NOTICE OF OBJECTION TO THE DRAFT RECORD OF DECISION FOR THE ATLANTIC COAST PIPELINE PROJECT LAND AND RESOURCE MANAGEMENT PLAN AMENDMENTS FOR THE MONONGAHELA NATIONAL FOREST, POCAHONTAS COUNTY, WEST VIRGINIA, THE GEORGE WASHINGTON NATIONAL FOREST IN HIGHLAND, BATH, AND AUGUSTA COUNTIES, VIRGINIA

Prepared for **Dominion Pipeline Monitoring Coalition** and **Wild Virginia**
Prepared by Pamela C. Dodds, PhD., Licensed Professional Geologist

Figure 1.3-1 – Watershed delineation (outlined in blue) for UNT to Lick Draft. The UNT watershed is approximately 72 acres and is located in the George Washington National Forest. The watershed delineation is superimposed herein on the map provided in Appendix B of the ACP FEIS.

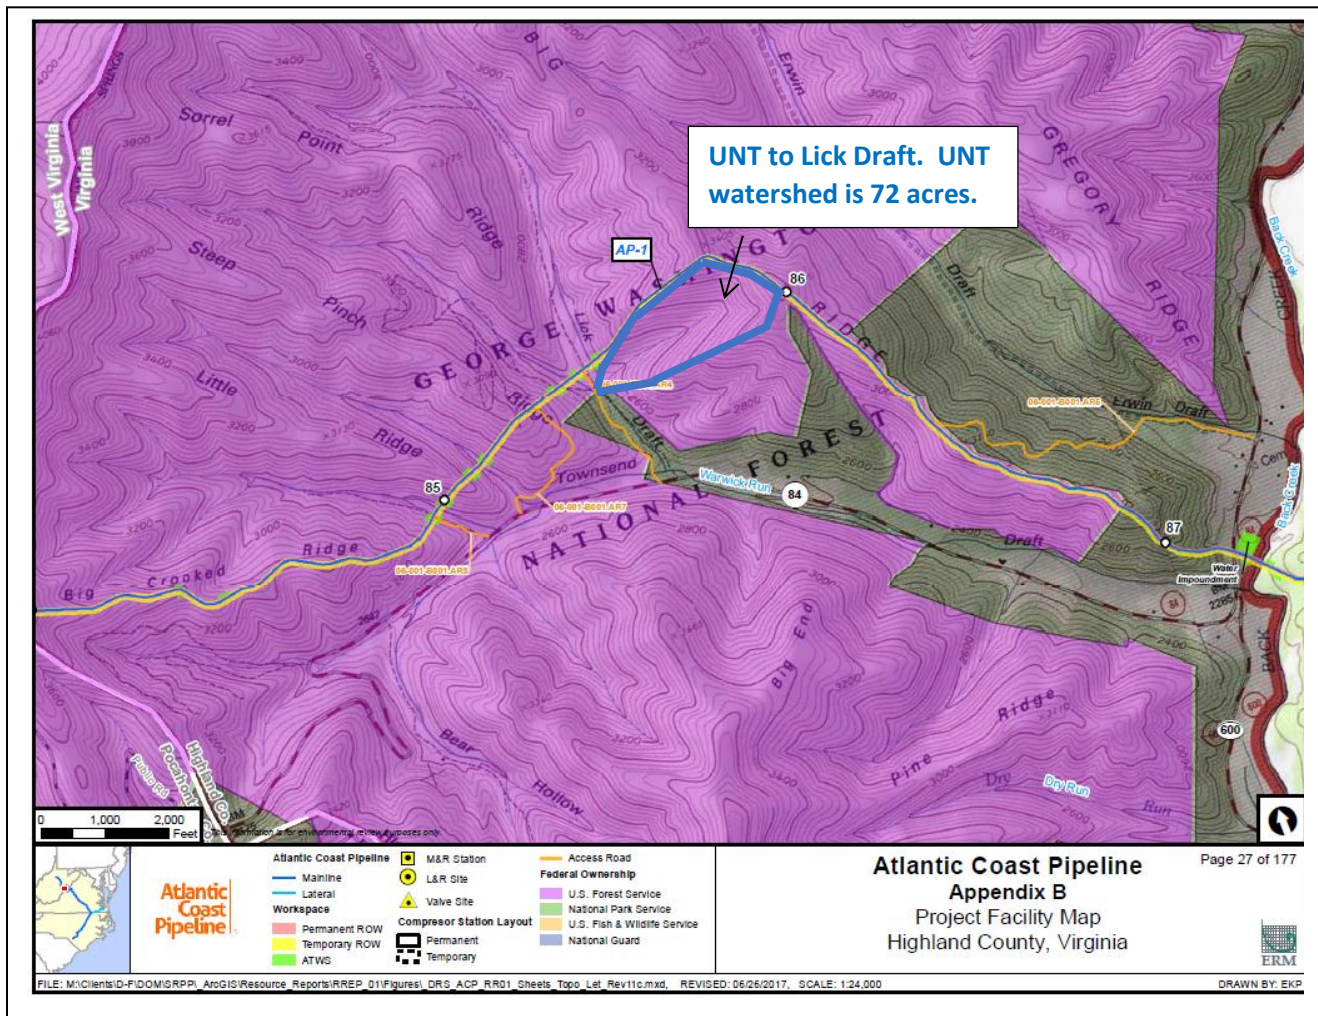
The drainage areas delineated by Environmental Resources Management (ERM) for DETI are provided in the report, “Appendix X – Access Road and Right-of-Way Post-Construction Stormwater Management Evaluation Report, *Atlantic Coast Pipeline*”, dated June 12, 2017, for the stated intent of addressing “compliance of ACP with Virginia’s water quantity and quality criteria as set forth in 9VAC25-870-66 and 9VAC25-870-63, respectively, and related Virginia Department of Environmental Quality (VDEQ) guidance.” ERM delineated 170 drainage basins within the entire area in Virginia proposed for the ACP construction in Virginia. Similar maps have not been provided to the WVDEP for areas within West Virginia. The drainage basins used for water quantity calculations range from 36 acres to 84,092 acres. Only 20 of the drainage basin areas are less than or slightly greater than 200 acres, which is the typical size for meaningful stormwater discharge calculations. The larger delineated drainage basins extend far beyond the watershed of upland first order high gradient streams that will be impacted by ACP construction activities. Ground cover estimates and stormwater calculations for watersheds exceeding the area of the upland first order streams, second order streams, and third order streams *obscure the impacts to functions within the smaller watersheds*.

For example, **Figure 1.3-1** depicts the watershed of an unnamed tributary (UNT) to Lick Draft, within the George Washington National Forest, superimposed onto the map of the area provided by ACP in Appendix B of the ACP Final Environmental Impact Statement (FEIS). Lick Draft is a tributary to Townsend Draft. The watershed for the UNT to Lick Draft is approximately 72 acres, extending from approximately Mile Post (MP) 85.5 to approximately MP 86.0. The proposed ACP work corridor extends a length of approximately one-half mile, or 2640 feet, with an approximate width of 125 feet, which is approximately 7.57 acres. The VDEQ states in the Virginia Stormwater Management Handbook (2013) that construction activities in the work corridor would render it functionally impervious. The 7.57 acres of impervious area created by the proposed ACP work corridor and access roads constitutes approximately 10 percent of the watershed area, thereby causing degradation to the receiving stream (VDEQ Stormwater Management Handbook, 2013).

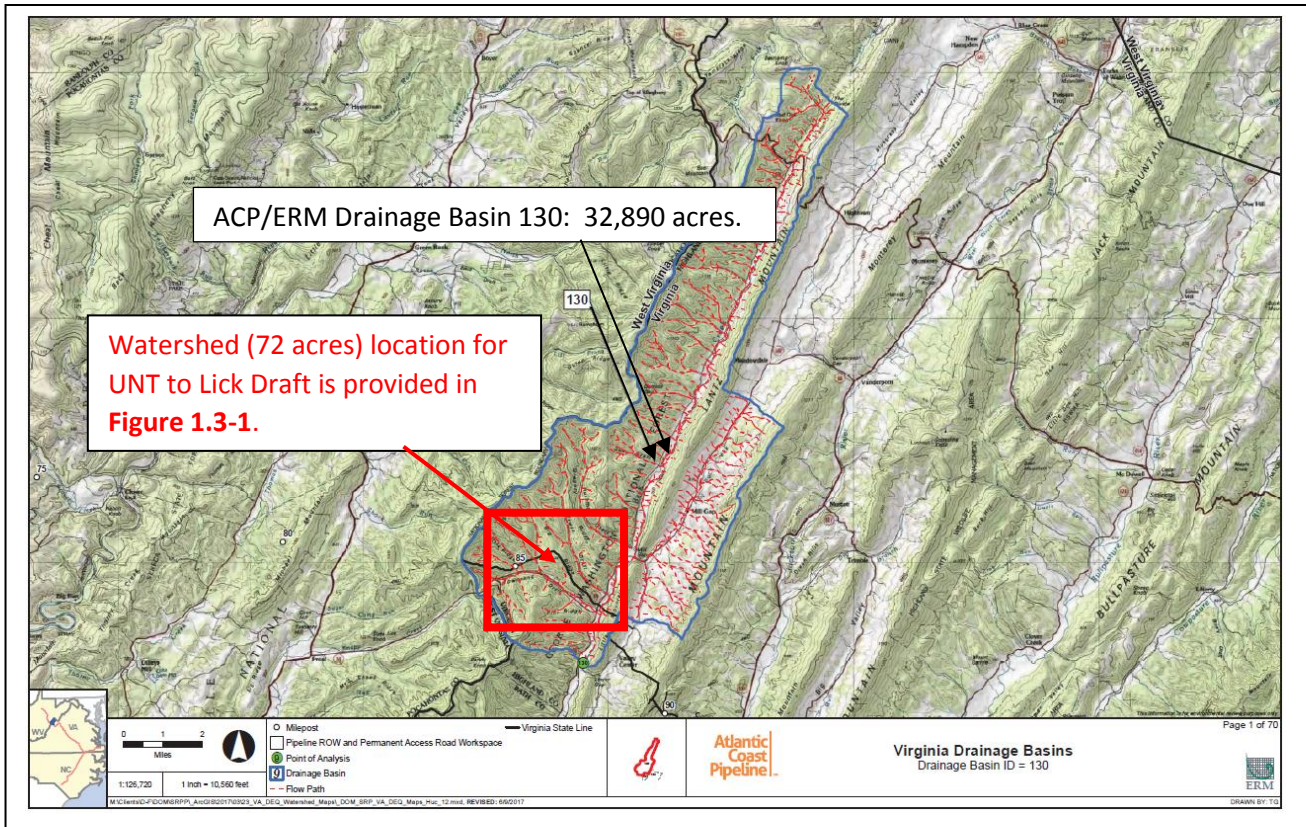
In ACP Appendix X, ERM provides delineated drainage basins for the proposed ACP construction area in Virginia. The watershed for the UNT to Lick Draft, depicted in **Figure 1.3-1**, is a small portion of ERM drainage basin 130, shown in **Figure 1.3-2**. The ERM drainage basin 130 is 32,890 acres, which is on the order of the HUC12 Subwatershed classification rather than the size of a watershed which should be used to conduct a functional assessment. ERM calculated stormwater discharge for the 32,890-acre drainage basin, using a “shrub land” category for the post-construction work corridor, even though such a construction area is considered by VDEQ to be *functionally impervious* (VDEQ Stormwater Management Handbook, 2013). Consequently, the stormwater discharge is based on ground covers that indicate the post-construction stormwater discharge is equal to the pre-construction stormwater discharge.

Peak stormwater discharge calculations for drainage basins of 32,890 acres, such as used in the ERM calculations, do not conform to those of functionally significant watersheds of first order high gradient streams. Such calculations do not constitute the Best Available Scientific Information and are, therefore, **inconsistent with the 36 CFR 219 planning rule requirement §219.3: using the Best Available Scientific Information (BASI) to Inform the Planning Process**. Similarly, proposed ACP access roads are stated to be at least 30 feet wide for two-way traffic, where practical and constructed by grading and removing all organic material (including roots), with a 6-inch course of VDOT #1 Course Aggregate applied immediately after grading. The Virginia Erosion and Sediment Control Handbook specifies placing stone at an 8- to 10-inch depth where heavy vehicles are expected. This would certainly apply to the proposed ACP access roads. Typical road construction dictates compaction of the subgrade and the overlying stone, such that the access roads will be impervious.

Figure 1.5-2 – ACP typical section demonstrating removal of elevated areas along the proposed ACP construction areas to create level work areas. This schematic diagram is excerpted from the ACP SWPPP submitted to the WVDEP.

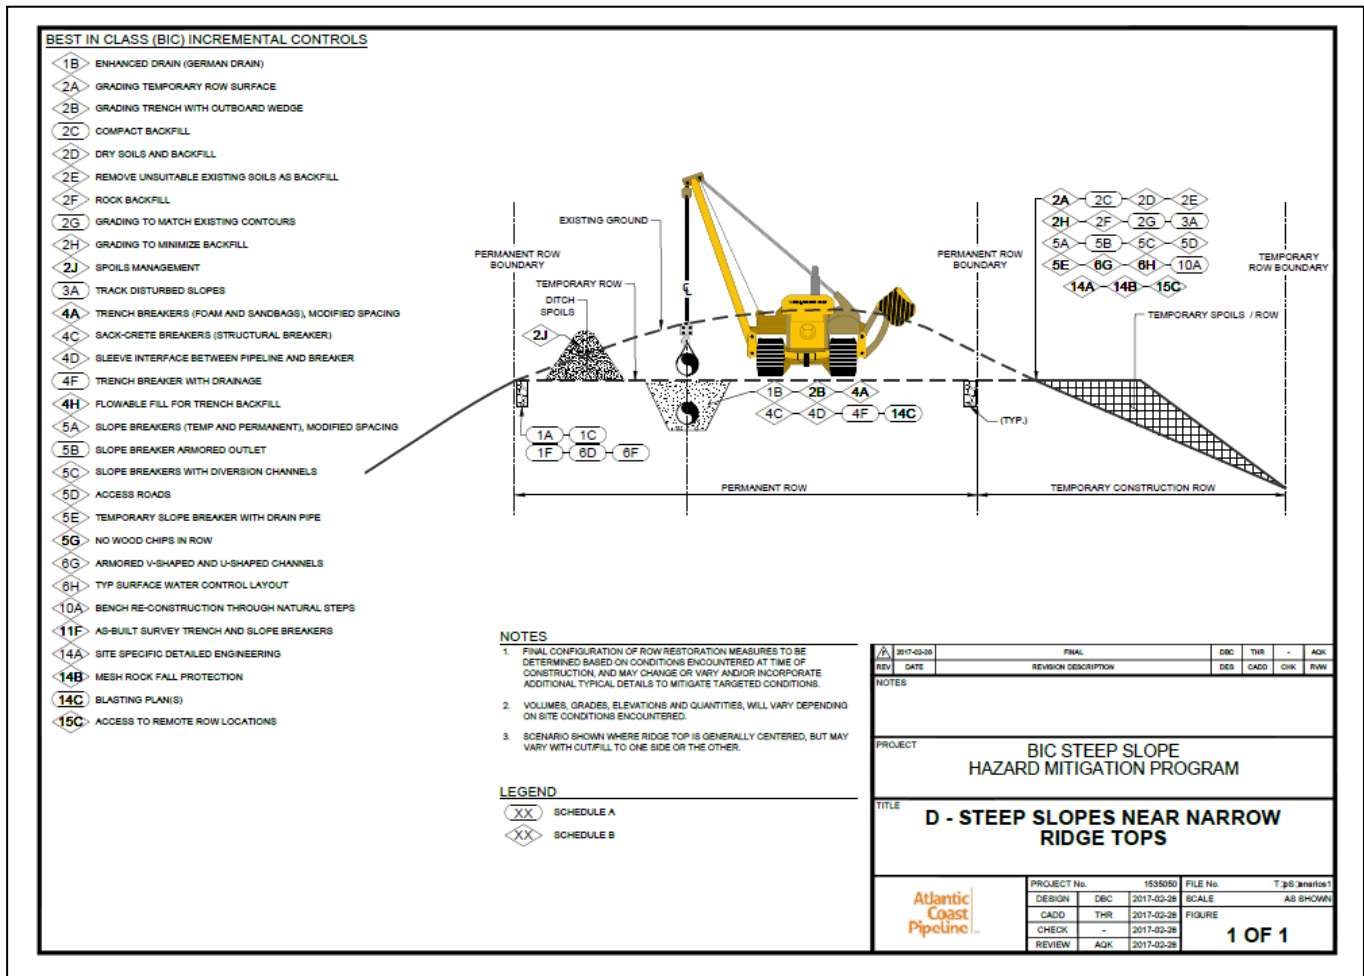
Figure 1.5-2 provides a schematic diagram showing ridgetop removal to create a level work corridor surface for pipeline construction activities. The schematic diagram is excerpted from Appendix O of the ACP Stormwater Pollution Prevention Plan (SWPPP), submitted August 25, 2017 by ACP to the WV Department of Environmental Protection. Where elevated areas are present in the work corridor or access road areas, excavation and/or blasting will remove the elevated area to be leveled within the proposed construction areas. The complete soil horizon will be removed, potentially to depths that will eliminate any root mass.

Figure 1.5-3 – ACP typical section demonstrating removal of elevated side slope areas along the proposed ACP construction areas to create level work areas.

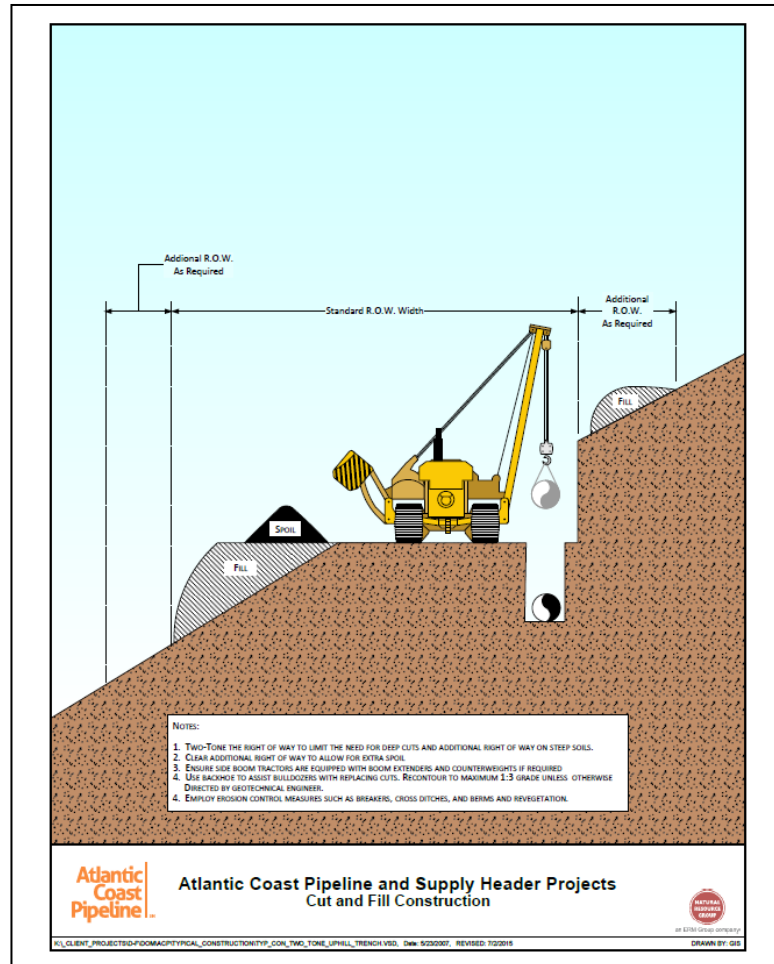
Figure 1.5-3 is excerpted from ACP typical construction diagrams, showing the procedure for side slope construction. Water from seeps and springs encountered during this procedure will be directed onto the ground surface.

Figure 2.3.1-1 – Topographic map of proposed ACP construction areas between MP 71 and MP 72. Headwater streams, wetlands, and seeps for Slaty Fork will be impacted by the proposed ACP construction. Map developed by P.C. Dodds using Terrain Navigator Pro mapping software.

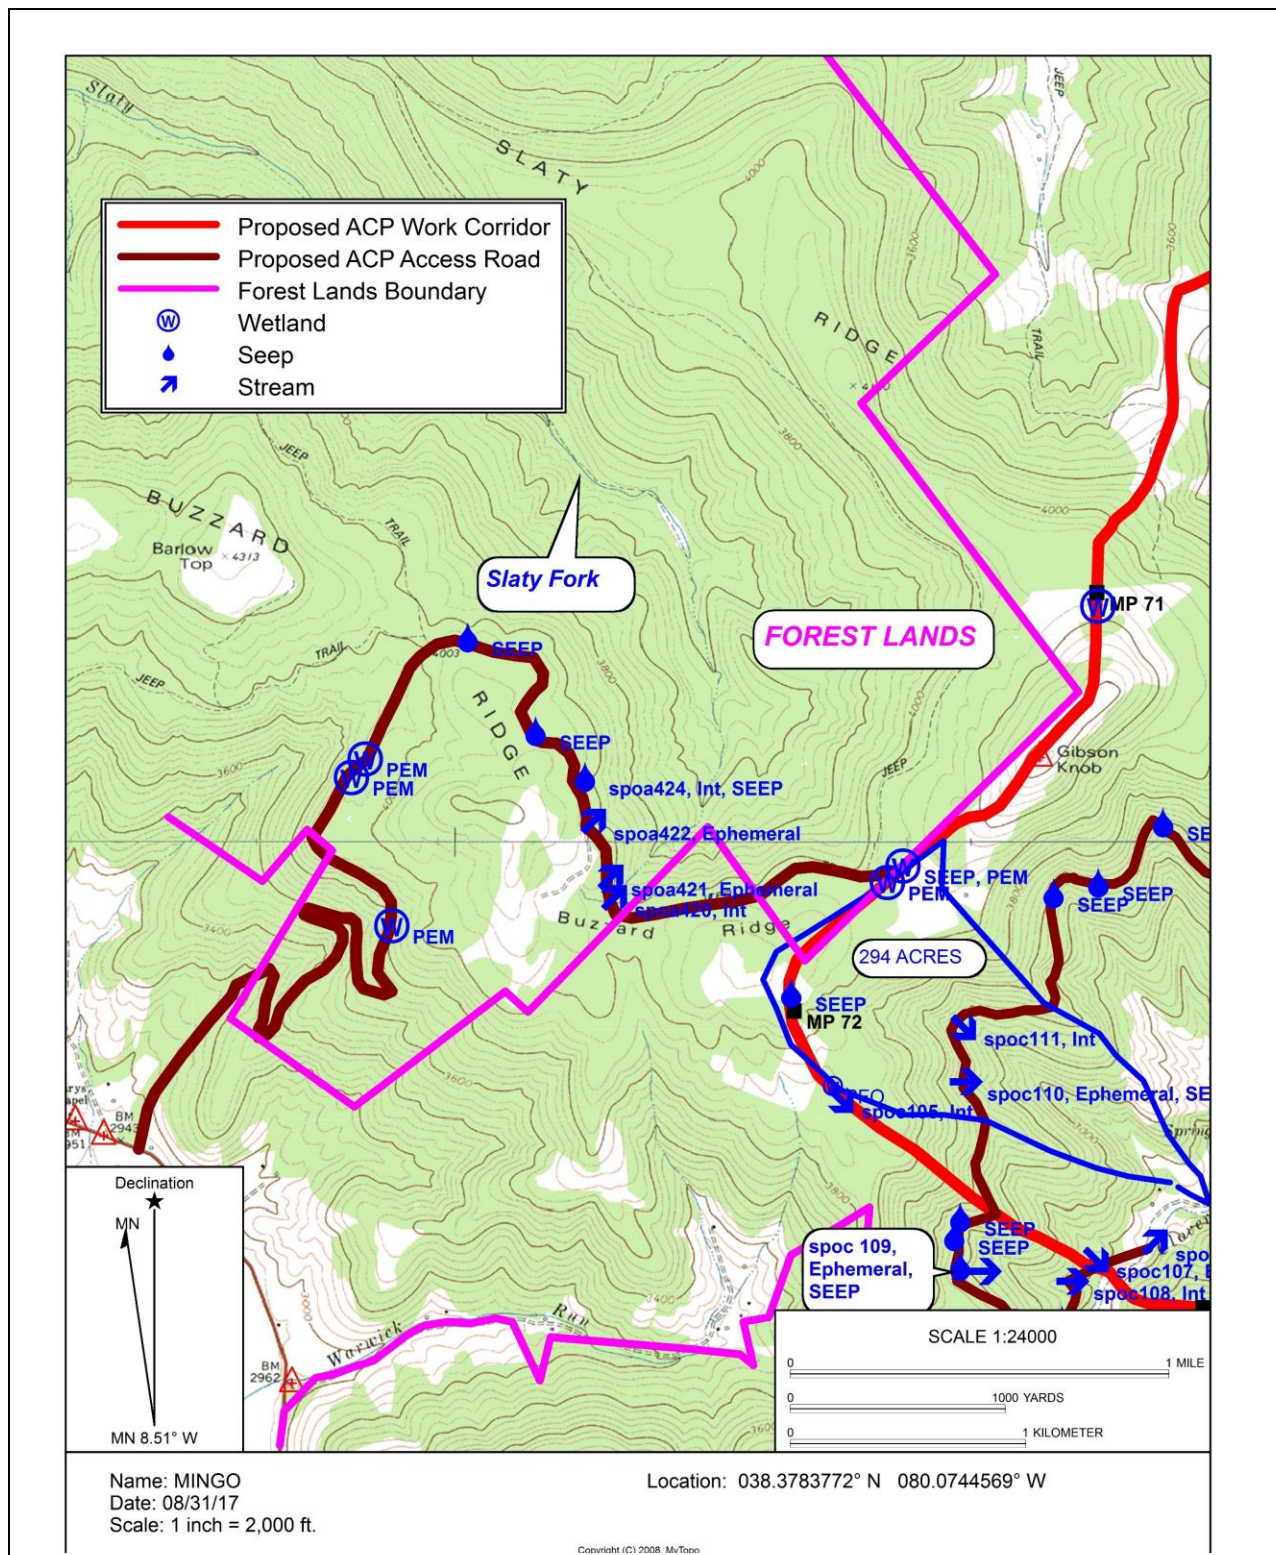
The proposed ACP access road construction extends along the side slopes of Buzzard Ridge within the Monongahela National Forest. The documented seeps and wetlands facilitate aquatic habitats for aquatic species at the base of the food chain in the river continuum in the uppermost segment of Slaty Fork. Groundwater maintains the seeps and wetlands. The documented intermittent streams are maintained by groundwater as well as precipitation. The ephemeral streams provide transport of precipitation to the headwater areas and to Slaty Fork. Groundwater maintains baseflow of water in Slaty Fork during times of drought. In the ACP SWPPP, it is stated under “9.5.2 Seeps” that, “In the event that subsurface flow is encountered, a subsurface drain or under drain will be utilized, as necessary, to divert water outside of the LOD. If encountered, seeps can be mitigated by using seep collectors placed down-slope of areas showing seepage. Armored fill placed at the toe of the slope may be used in areas of steep slopes in addition to a perforated drain pipe to divert subsurface water away from the cut slope.” This construction activity, therefore, will provide permanent conduits to deprive the headwater areas of Slaty Fork from receiving groundwater to maintain headwater aquatic habitats.

The proposed ACP work corridor for trenching, soil stockpiling, and pipe installation activities is located along Buzzards Ridge, which is the drainage divide for the Slaty Fork watershed. Wetlands and seeps, documented by ACP contractors, are located in the proposed ACP work corridor. In addition to seep collectors and pipes installed to divert the subsurface water away from the work corridor, ACP stated in the WVDEP SWPPP that periodic dewatering will, “remove accumulated water or precipitation from the construction ROW, including from within the trenchline.” Water from such dewatering activities is then to be “discharged into areas where adequate vegetation is present adjacent to the construction ROW to function as a filter medium.” This would constitute concentrated flow of water into the vegetated areas, which would result in erosion.

Soils within the proposed ACP work corridor between MP 71 and MP 72 are documented by ACP as Cateache soils and Mandy soils. Cateache soils consist of extremely acid to very strongly acid channery silt loam developed on residuum weathered mainly from red interbedded siltstone and shale of the Mauch Chunk Group and Maccrady Formation. Depth to bedrock is 20 to 40 inches for Cateache soils. Mandy soils consist of extremely acid to very strongly acid channery silt loam developed on residuum and/or creep deposits (colluvium) weathered from interbedded shale, siltstone, and fine-grained sandstone. Depth to bedrock is 20 to 40 inches for Mandy soils. Colluvium is indicative of continual landslide activity.

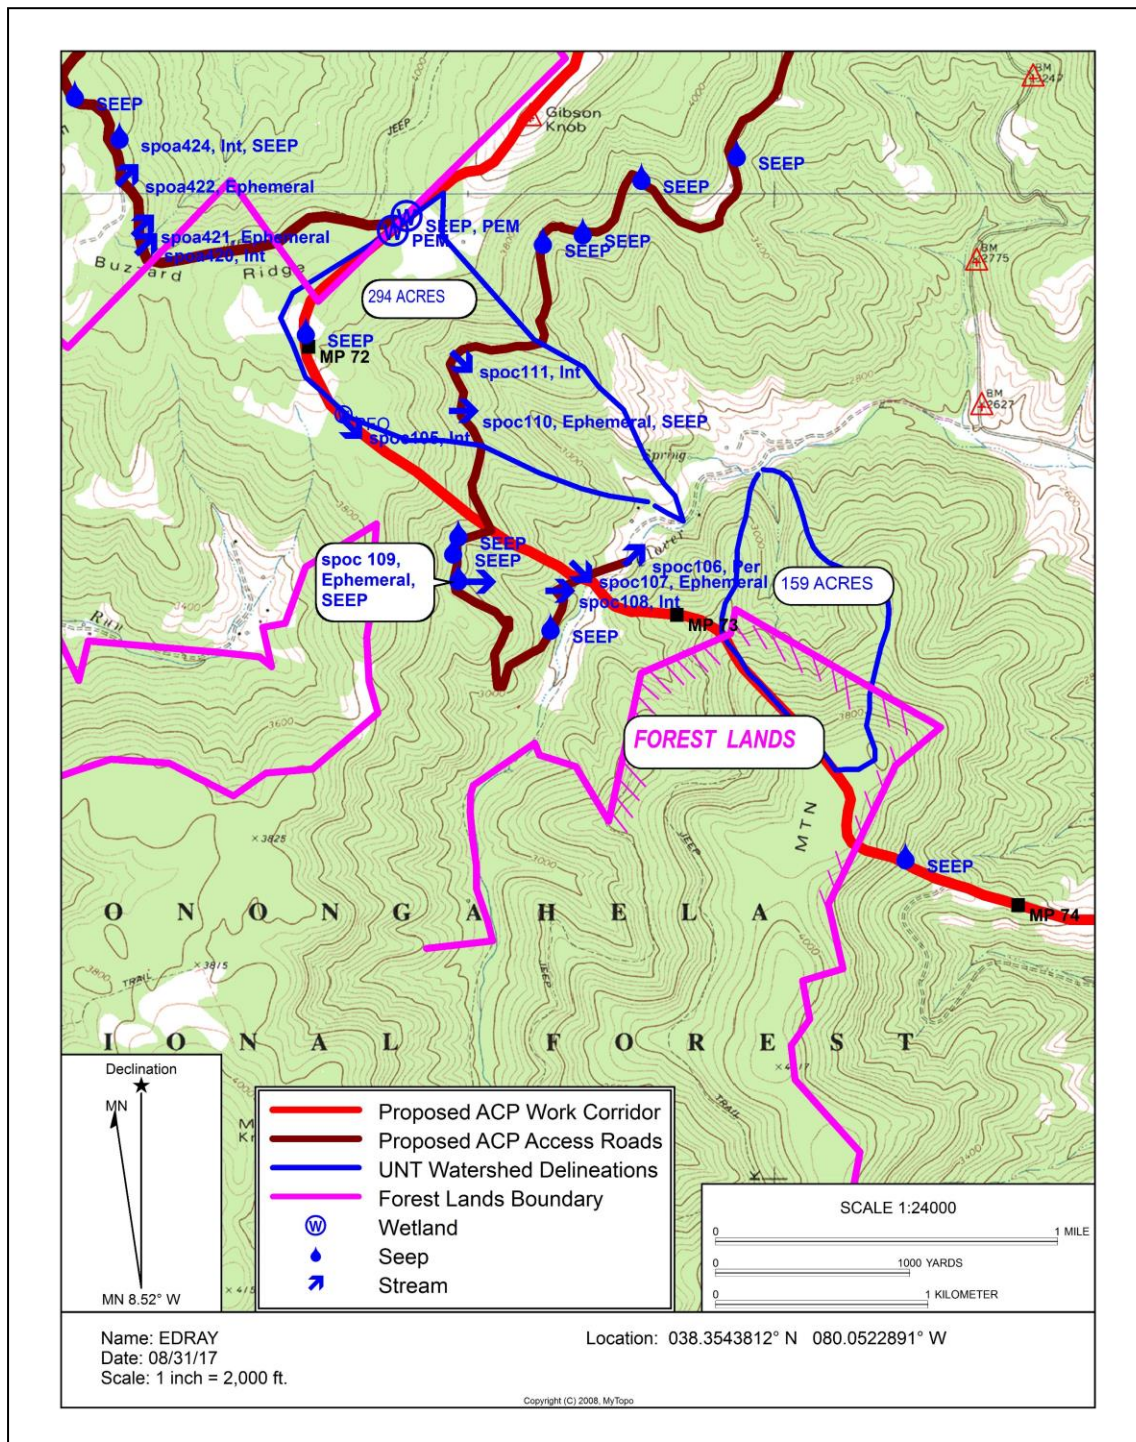
Deforestation (resulting in greater stormwater runoff and reduced groundwater recharge), soil compaction, and trench dewatering as well as side slope seep dewatering will lower the groundwater table and reduce the amount groundwater to maintain aquatic habitats in the headwater areas of Slaty Fork, a Tier 3 stream. The presence of creep (colluvium) deposits on the hill slopes indicate soil landslide activity, which will facilitate movement of sediments toward Slaty Fork.

Blasting may be necessary because bedrock is 20 to 40 inches from the ground surface. Blasting will cause changes in the quantity and flow direction of groundwater. Such changes in groundwater, along with reduced groundwater recharge, will reduce the hydraulic head, causing permanent changes in groundwater movement downgradient. Impacts will result by reducing groundwater availability to maintain aquatic habitats in the headwater areas of Slaty Fork and also reducing groundwater baseflow to Slaty Fork during times of drought.
